## ORIGINATION FORM

### Proposed Revisions to a Standard Plans Index (Please provide all information — Incomplete forms will be returned)

Index Number: 641-020

Index Title: Concrete CCTV Pole

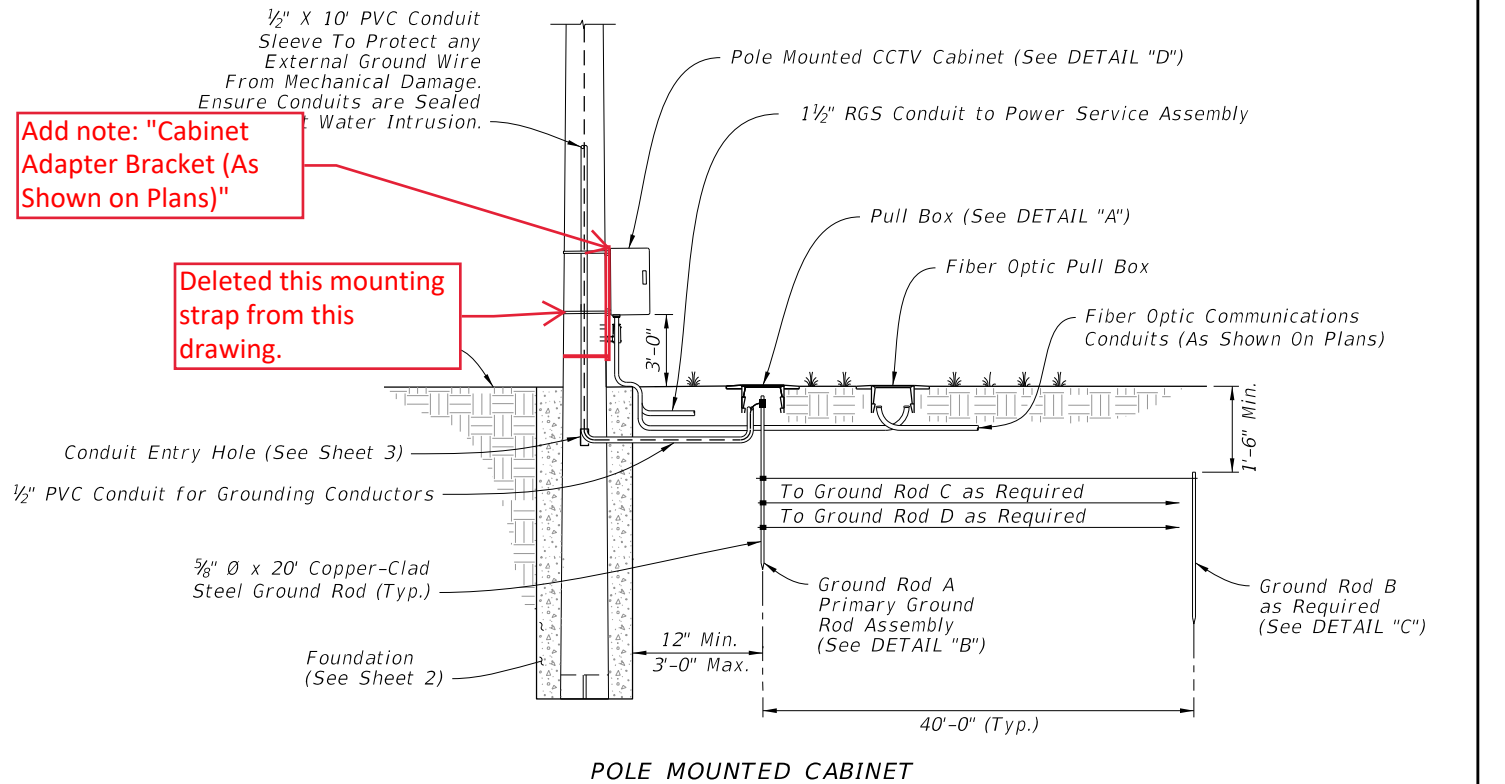
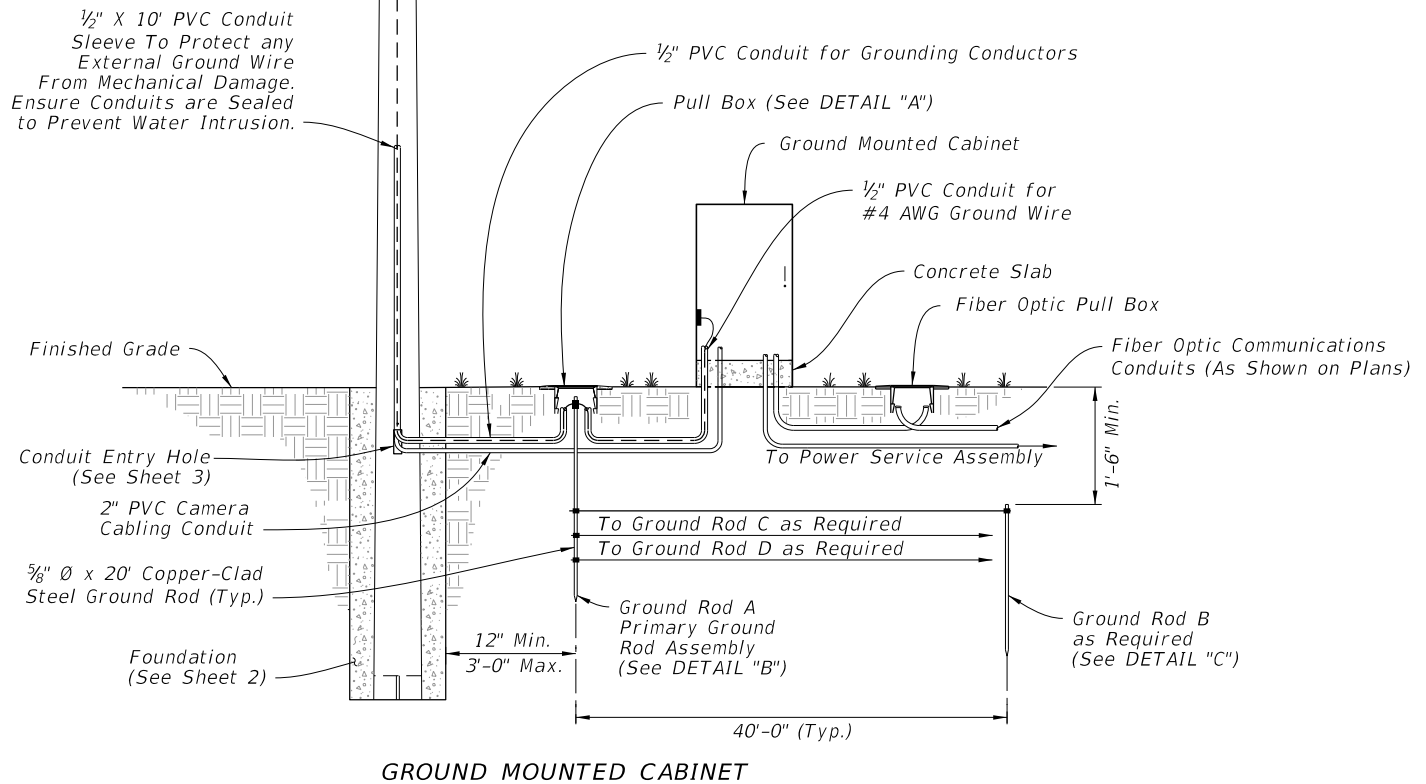
**Added note: "Cabinet Adapter Bracket (As Shown on Plans)"**

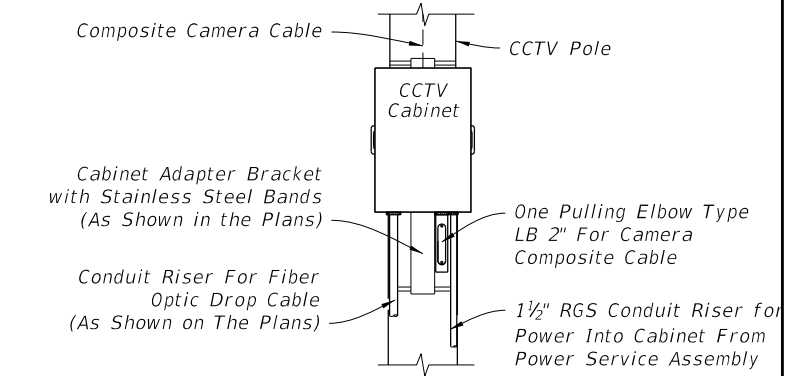
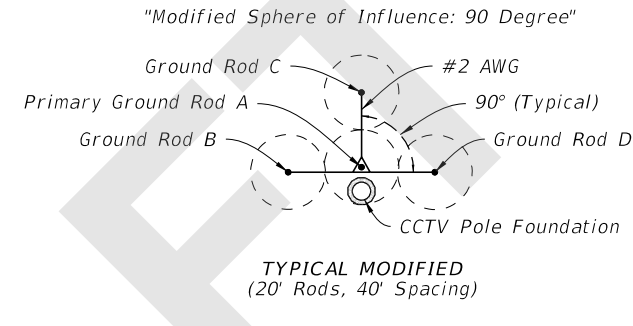
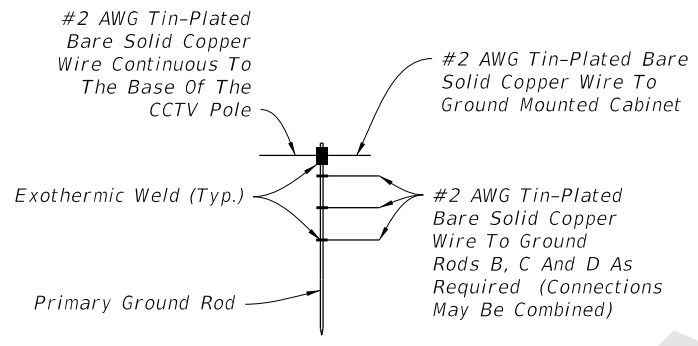
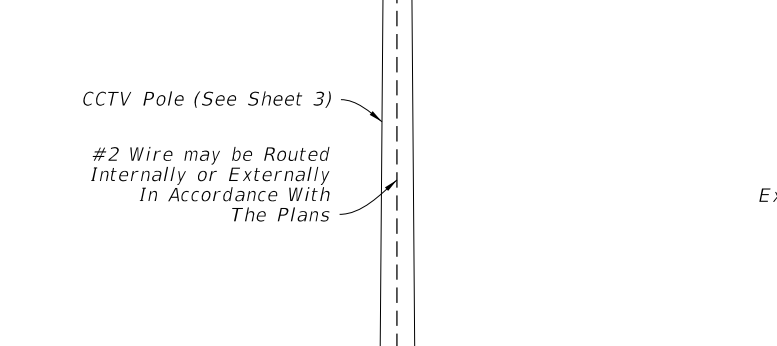
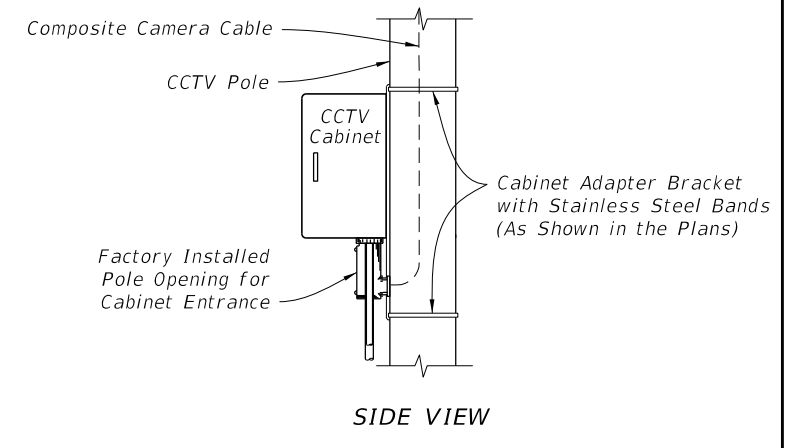
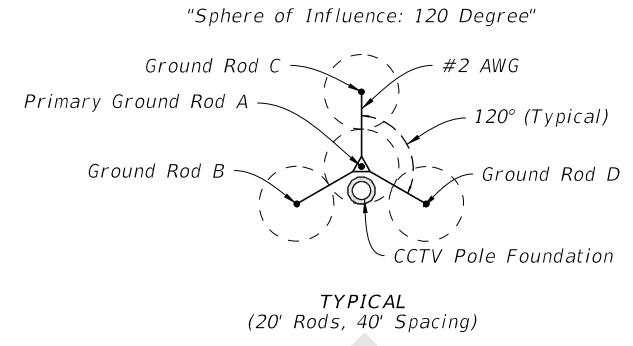
**Deleted this mounting strap from this drawing.**

**Add note: "Cabinet Adapter Bracket (As Shown on Plans)"**

**Move this LB to the right.**

DETAIL "D"

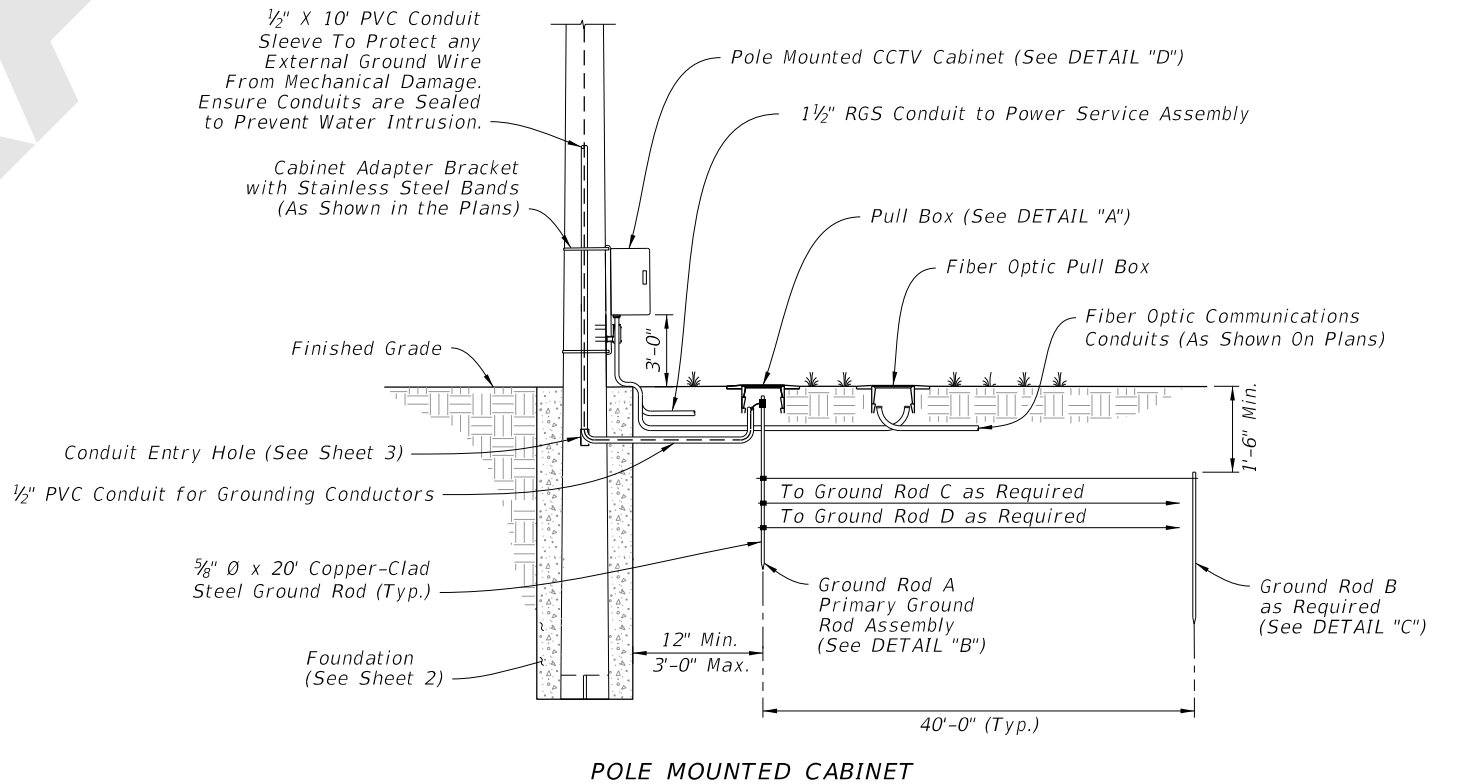
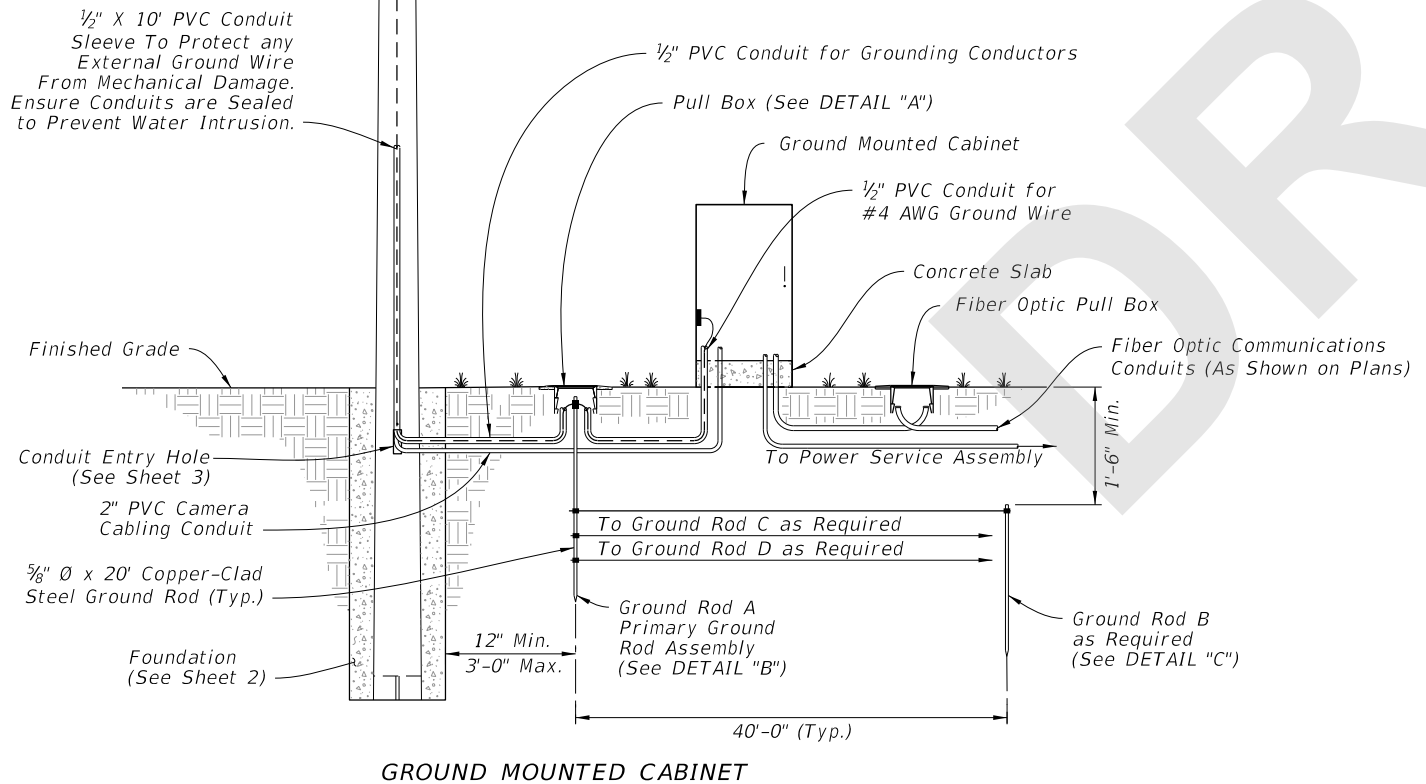
Sheet 5: Deleted the "Pole Plate With Stainless Steel Band" and Added new "Cabinet Adapter Bracket" shown in DETAIL "D" and the POLE MOUNTED CABINET detail.

"676-2.5.9 Adapter Bracket: If shown in the plans, provide an adapter bracket for pole mounted cabinets that is slotted or otherwise designed to allow banding straps to be installed to avoid pole handholes."
